# UNITED STATES PATENT AND TRADEMARK OFFICE

APPLICATION NO.	FILING DATE	FIRST NAMED INVENTOR	ATTORNEY DOCKET NO.	CONFIRMATION NO.
10/773,107	02/05/2004	Chris Rhodes	60130-2016; 02MRA0393	3984

## Office Action Summary

Attachment 1

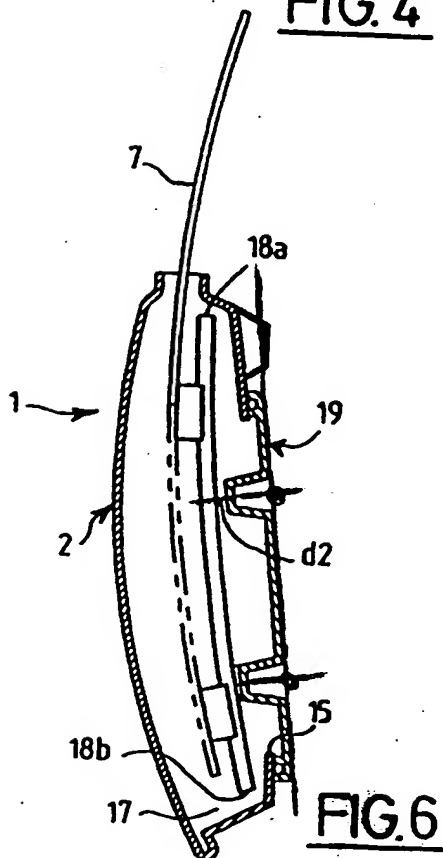
Bertolini et al. disclose a door module with parallel window regulator rails (18), window regulator (5), and a trim panel (19). The window regulator rails (18) can be separably fixed to the trim panel by clips, disclosed on lines 4-6 of column 6. The rails are fastened to the trim panel (19) at upper and lower regions of the rails (18). Specifically, the attachment locations are on folds (12). A line projects perpendicularly from upper fastening point

intersects the plane defined by the trim panel at a point outside the trim panel, as shown the Attachment 1.

*Attachment 2*

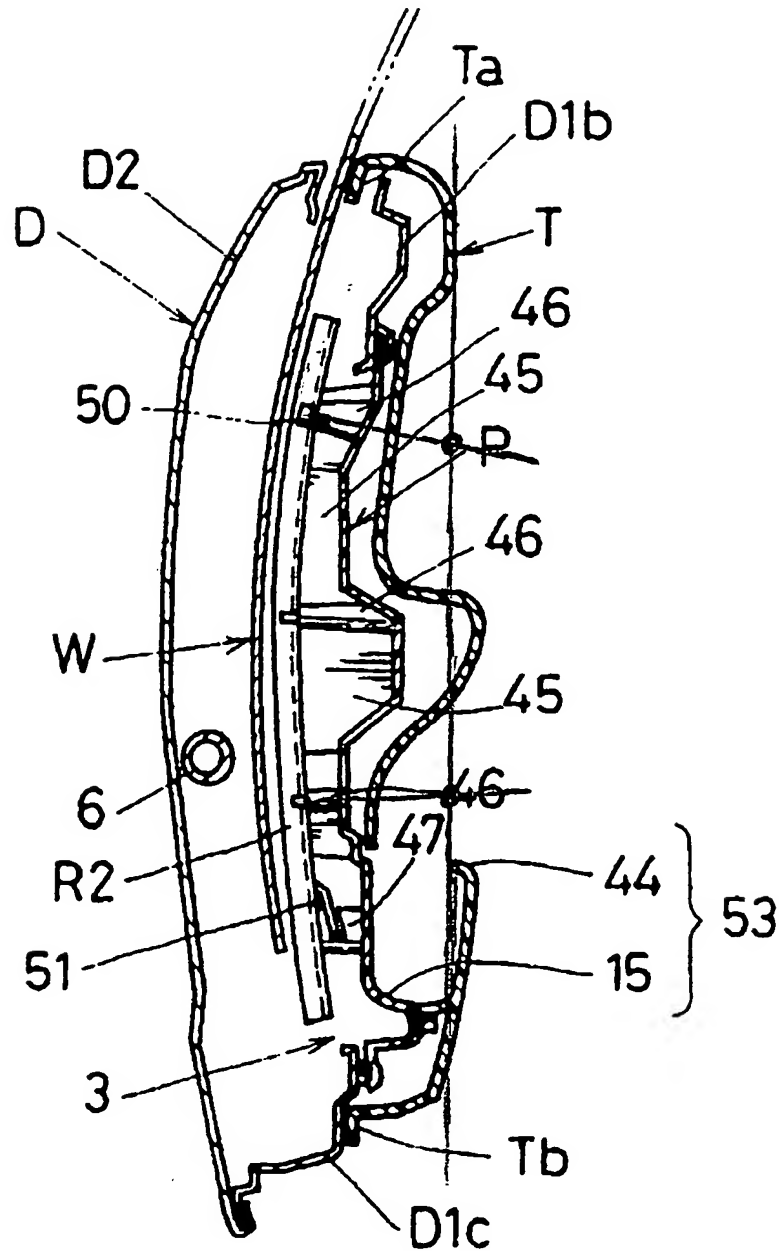
Nishikawa et al. disclose a door module with a window regulator rail (R2), a window regulator (R1), and a trim panel (P). The window regulator rail is separably fixed to the trim panel (P). The rail (R2) is fastened to the upper and lower regions of the trim panel (P). An electric window regulator control (40) is attached to the trim panel (P) and has wires that connect it to the window regulator (R1). A door handle (30) and a lock (33) are detachably mounted to the trim panel (P). A line projects perpendicularly from upper fastening point intersects the plane defined by the trim panel at a point outside the trim panel, as shown the Attachment 2.
